CONDITIONS OF APPROVAL:

Engineering - Site Plan Checklist

### 2016-11-28 Prime Health Site Plan - PreApp.pdf

### 2017-05-04 Prime Health Site Plan Combined.pdf

1. D. Site Plan

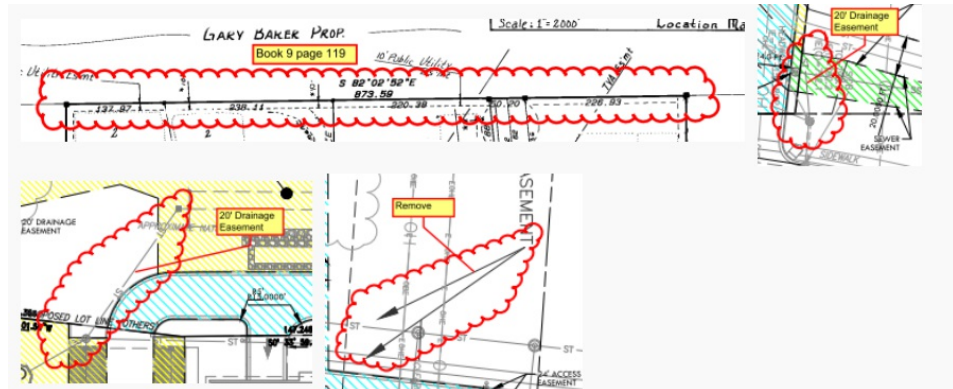
[joe.marlo@franklinton.gov](mailto:joe.marlo@franklinton.gov) Applicant has added an easement plan on Sheet C5.3 for clarity (thank you).

Applicant to revise the Easement Plan as follows:

1. Hatch for Green Infrastructure Easement is not consistent at GIE's. All bioretention should be shown with the GIE hatch (3 locations).
2. The existing 10' PUDE on the property to the south is to be shown (Plat Book 9 pg 119). Revise all affected sheets accordingly.
3. 20' Drainage easements are to be provided where clouded below.
4. Remove inadvertent leaders, including those clouded below.

#### 9. Landscaping

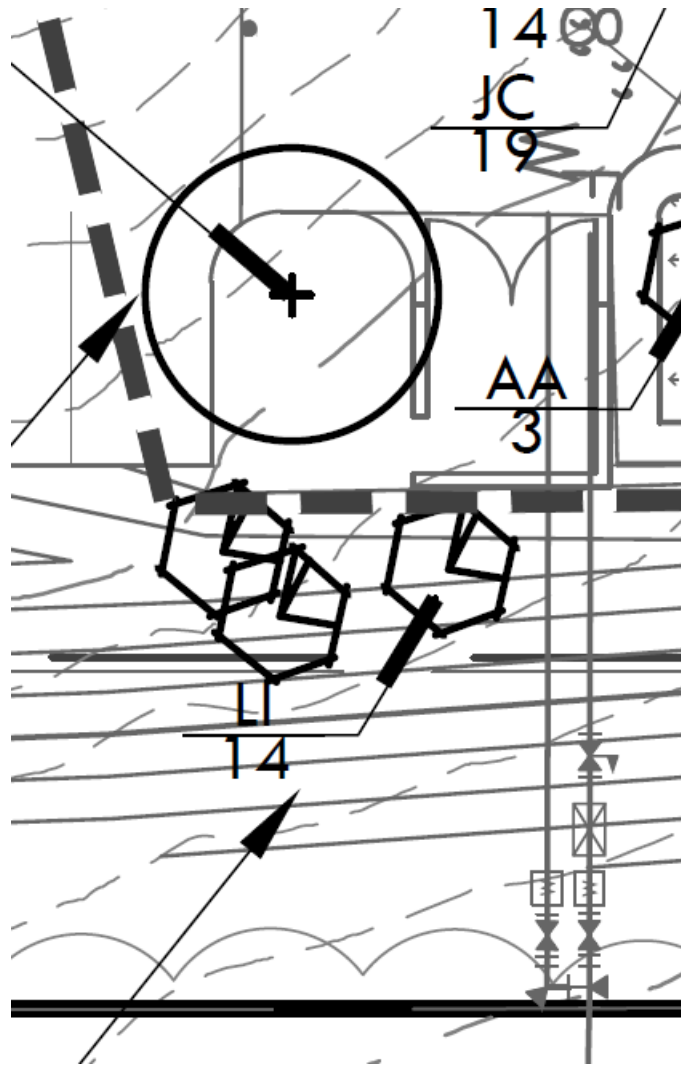
[geoffw@franklintn.gov](mailto:geoffw@franklintn.gov) This is a new comment at Resubmittal based on a change to the plans by the applicant. An earlier comment addressed non-compliance with the proposed location of domestic and fire protection water lines under the proposed dumpster enclosure. Based on those comments, the applicant relocated the domestic and fire protection water lines to the left of the dumpster enclosure.

However, landscaping on L1.0 was not adjusted and the water lines are now shown under a proposed "October Glory Red Maple" tree. The long-term root growth of trees poses a significant risk to water lines and fire protection water lines and must be avoided.

The applicant shall remove the proposed maple tree from the location indicated to avoid damage to domestic and fire protection water lines.
